Location:	2100 Telegraph Avenue (See map on reverse)
Assessor's Parcel Numbers:	008-0648-001-00; -011-03; -016-03; -017-00 & -018-00
Proposal:	Design Review discussion for two potential final development plans for the entirety of the Eastline Project Planned Unit Development. The different development plans are as follows: Scheme A – Proposal would include a mixed-use development with approximately 80,000 square feet of ground floor retail, approximately 18,000 square feet of community and/or assembly space, approximately 880,000 square feet of office in a building that is broken into three masses varying in height from 180 feet to 240 feet, and 395 dwelling units within a high-rise tower of approximately 440 feet in height at the corner of Broadway and 22nd Street. Scheme B – Proposal would include a mixed-use development with approximately 69,000 square feet of ground floor retail, approximately 22,000 square feet of community and/or assembly space, and approximately 1,500,000 square feet of office use. The building would include building massing for most of the site with a height of approximately 215 feet and a large office tower along the Broadway frontage that would be 29 stor

PODIUM PARKING ANALITIQUE COMPARISON

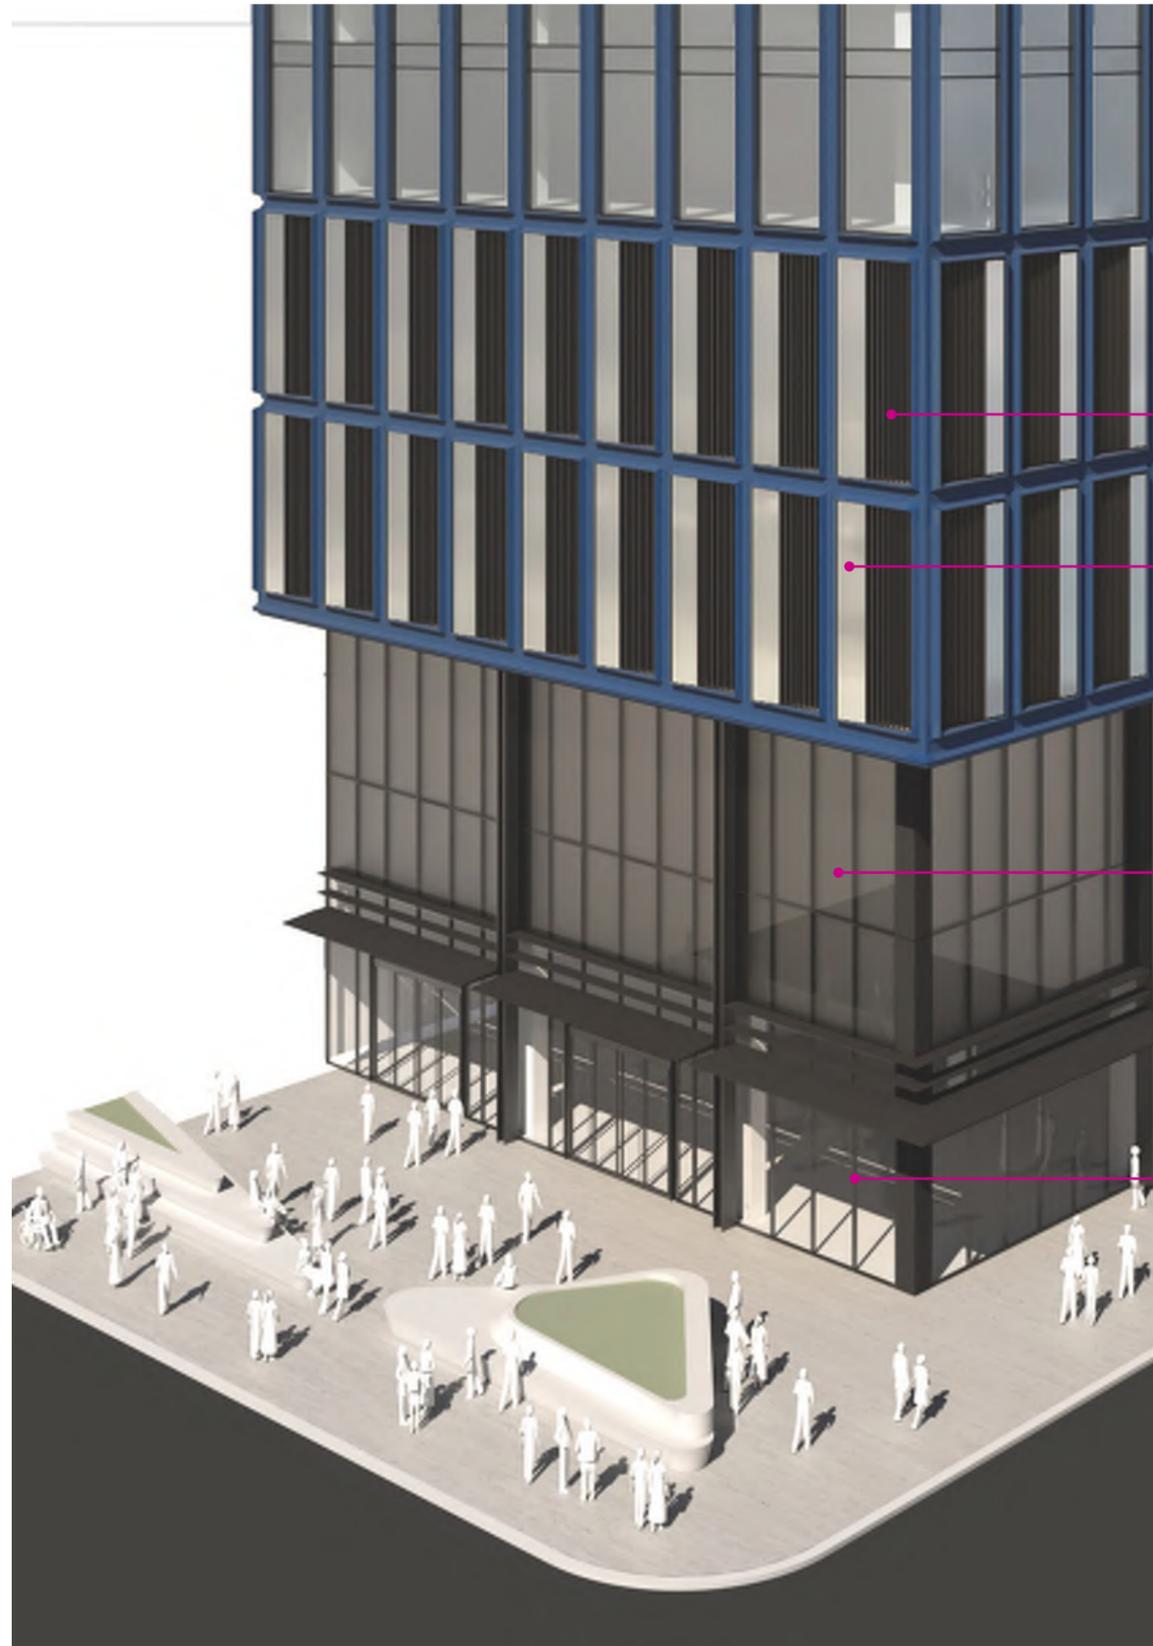
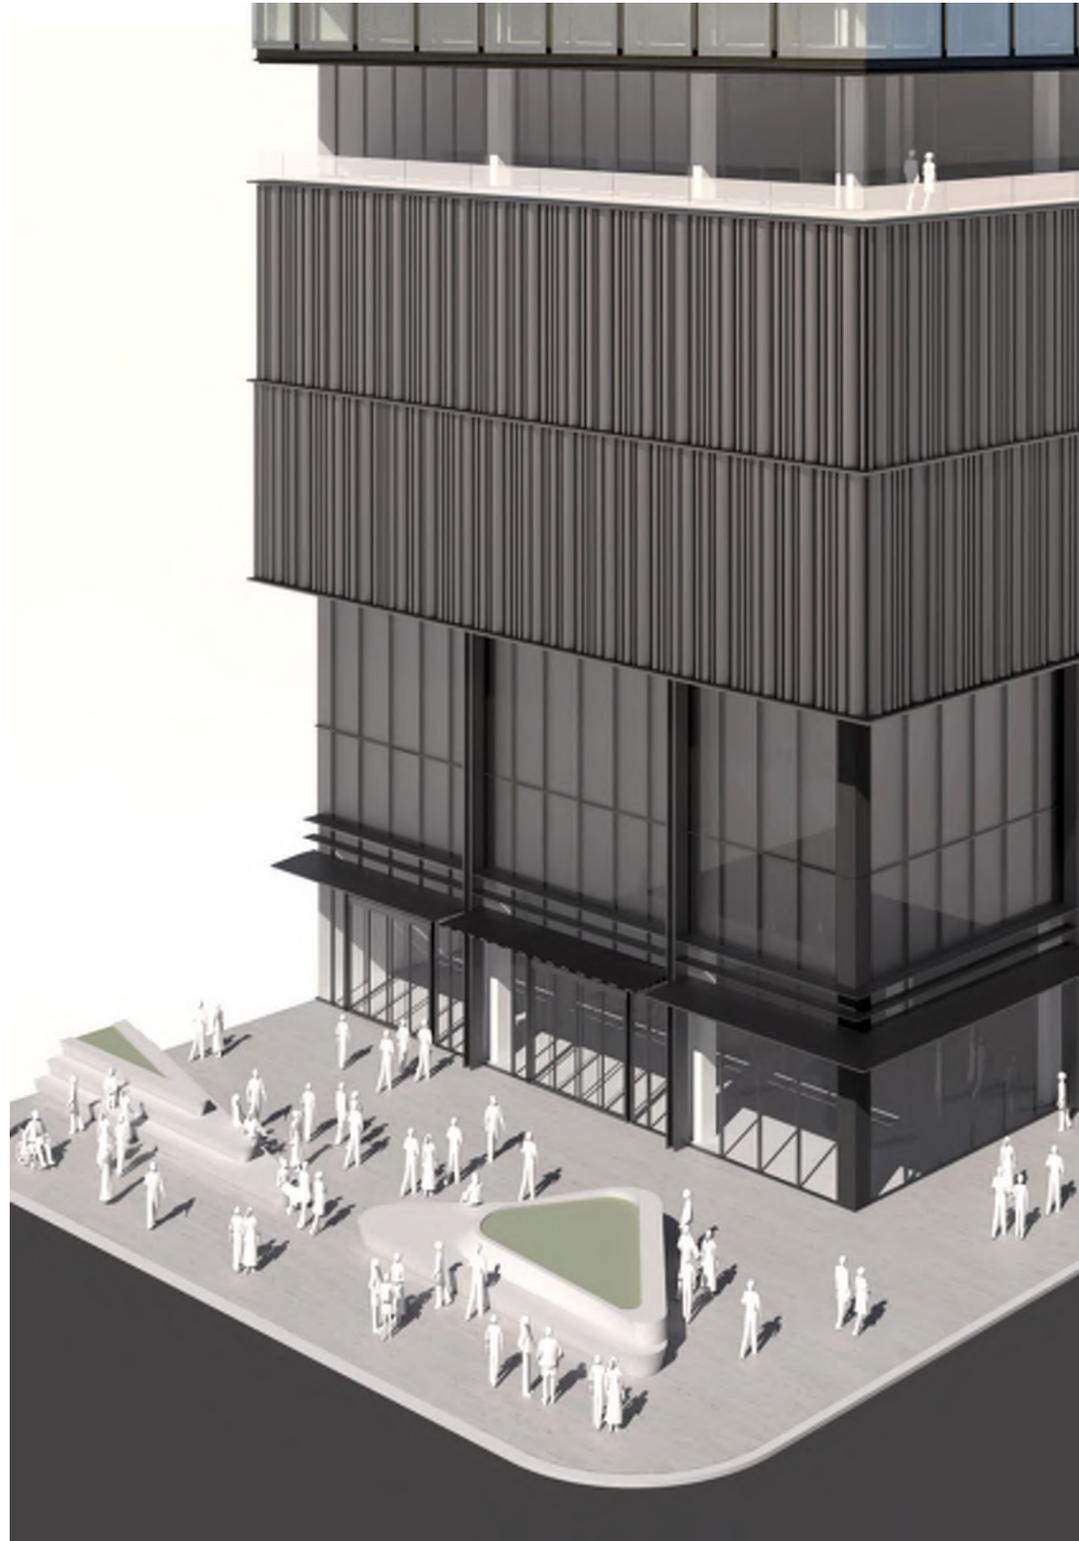
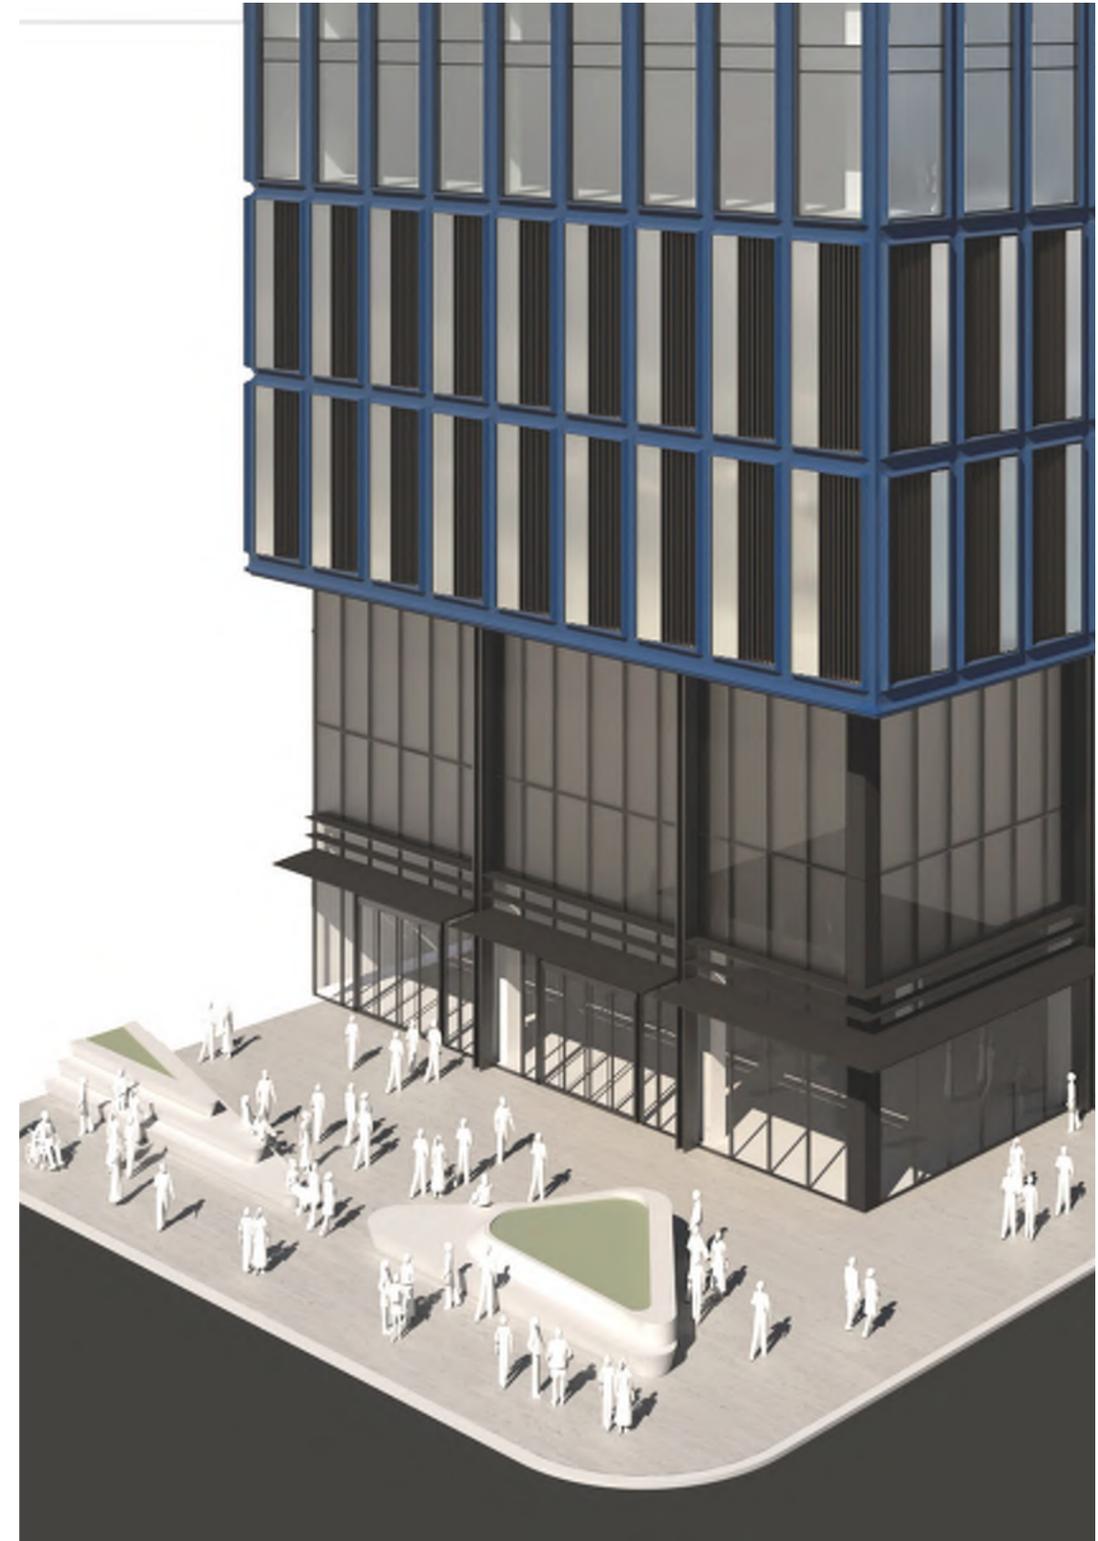
- Garage Screening - Concerns were raised over proposed garage screening and a request was made to provide additional information on the proposal. The applicant has provided a revised design to the garage screening in both Scheme A and B that removes textured aluminum screen concept and replaces it with a design that is more integrated into the façade vocabulary of the building.

REVISED PARKING ANALITIQUE

DRC #1 TOWER CROWN

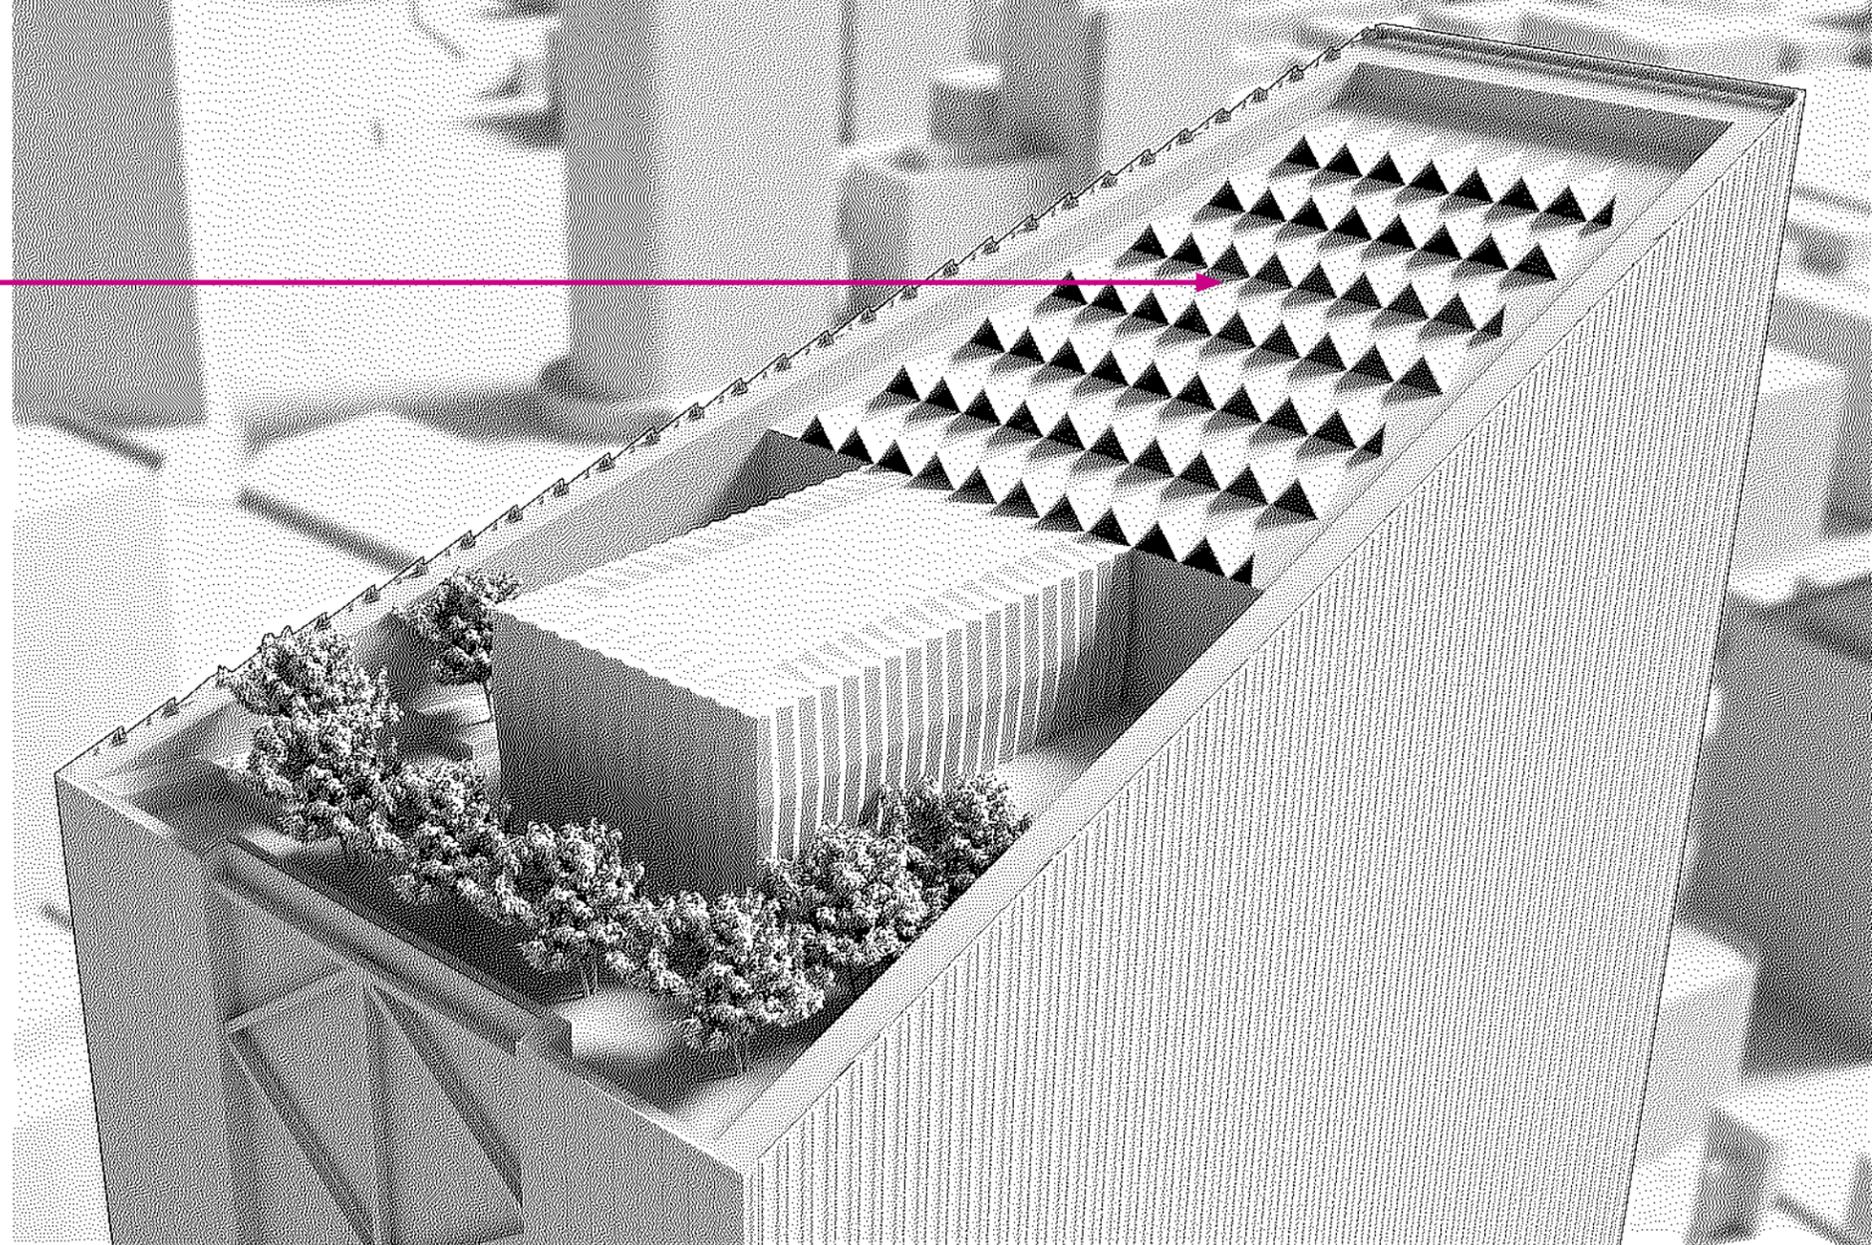
- Tower top in Scheme B – The concern was that the back side of the tower rooftop and northern (rear) face felt unfinished. The applicant has provided a revised design that provides more façade articulation to the northern façade of the building as well as incorporating screening elements into the rooftop to provide more of an enclosed and finished appearance.

RESIDENTIAL TOWER ANALITIQUE

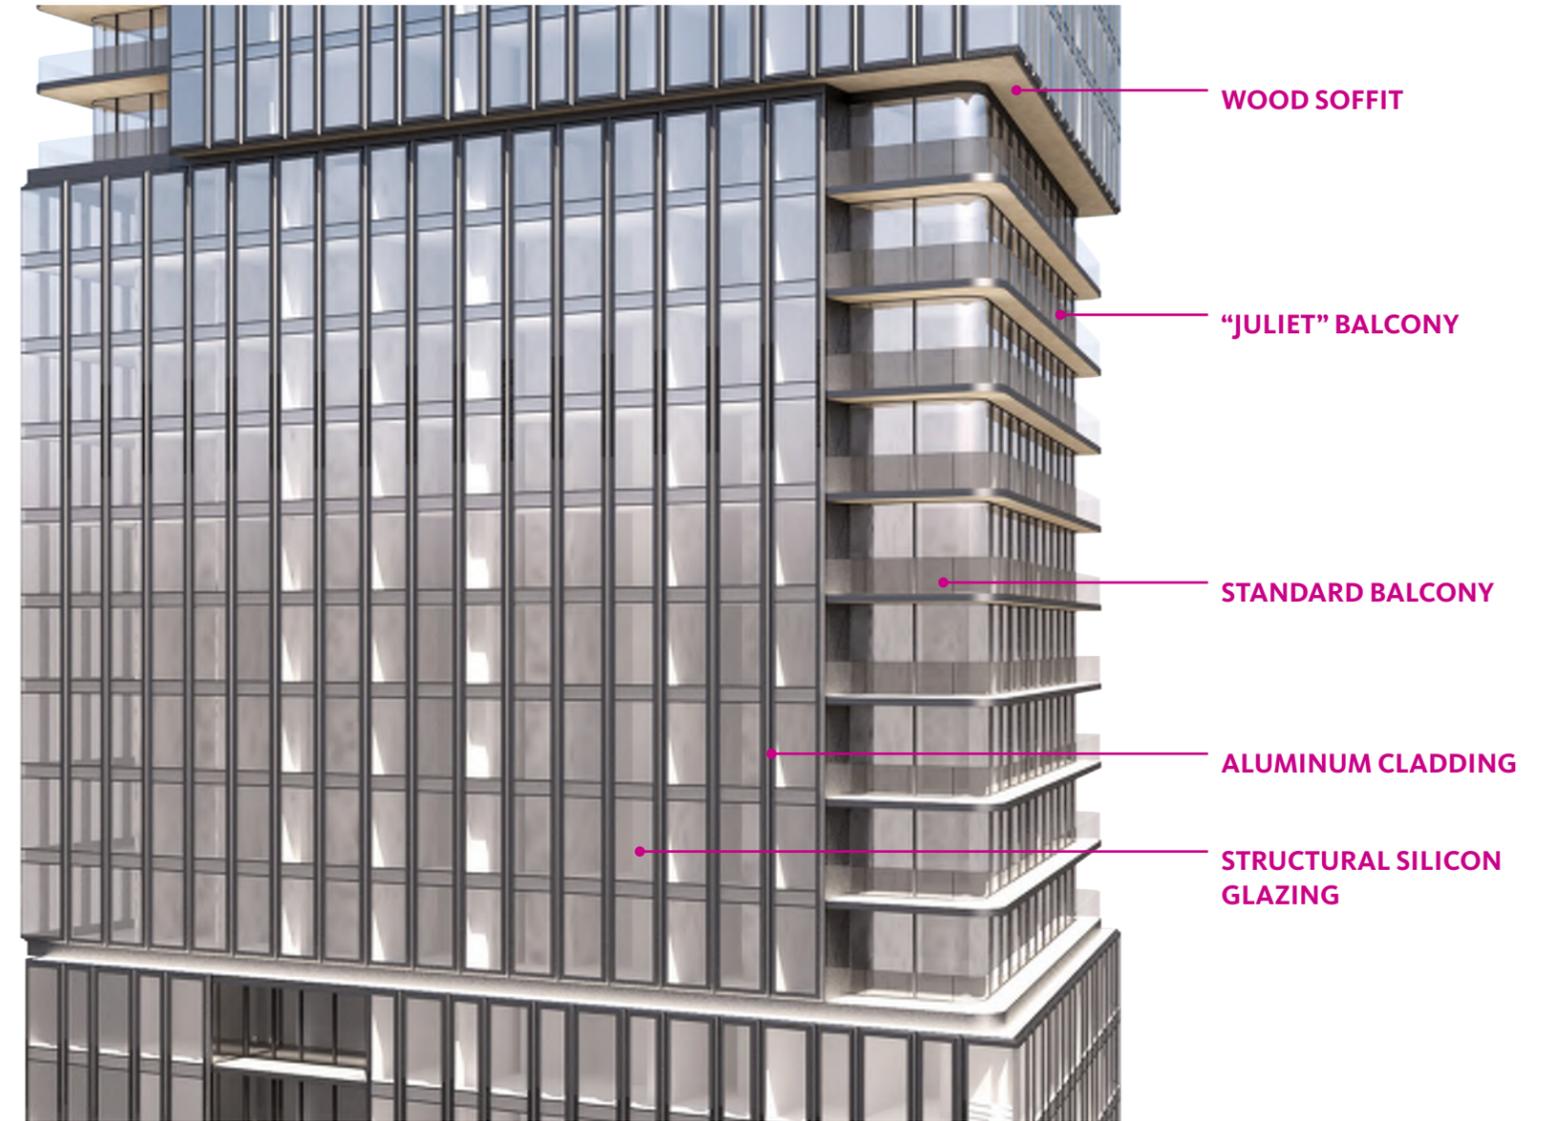
- Scheme A Tower Design – Staff has raised concerns over the overall design concept of the residential tower at Broadway and 22nd Street in Scheme A. The proposal includes a design concept that appears to have offset stacked blocks by alternating the locations of a series of balconies in contrast to a curtain wall system. This concern didn't seem to be further commented on by DRC members at the last meeting, but staff would still like to raise this item for discussion. While the design concept may be successful on a lesser scale, staff questions the appropriateness in this instance where it would become one of the tallest buildings in the Oakland skyline. The misalignment of the cubed massing appears to add a very horizontal appearance to the building which as one of the tallest buildings in the skyline should be of a more vertical orientation.
